A1 in Northumberland: Morpeth to Ellingham

Scheme Number: TR010059

7.6A Statement of Common Ground with Northumberland County Council

**Statement of Common Ground with
Northumberland County Council**

PEDESTRIAN - CYCLE LINK MORPETH TO FELTON

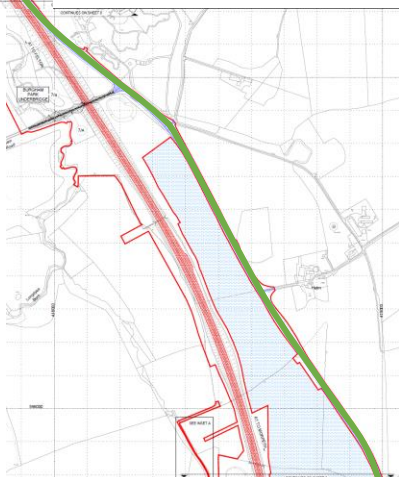
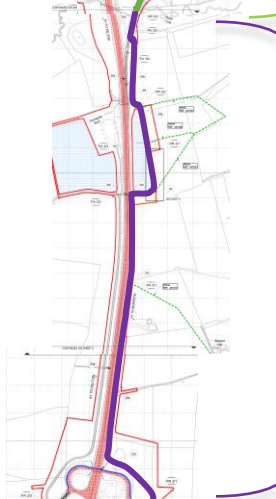
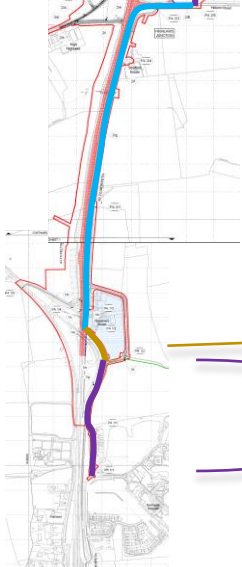
Footway/Cycleway as shown
On PRow and Access Plans
Constructed in accordance
With NCC Cross Section

New Footway/Cycleway to
Continue from Northern
Section Constructed to NCC
Cross Section Requirements

Footway connection
from junction footway to
existing footway on de-
trunked A1

New Footway/Cycleway to
Continue Constructed to NCC
Cross Section Requirements

New Footway/Cycleway to
Utilise Existing and Proposed
PRow Routing to Continue
Linkage - design to be agreed

New / Existing Footway
Be Widened to Allow
Footway/Cycleway
Designation
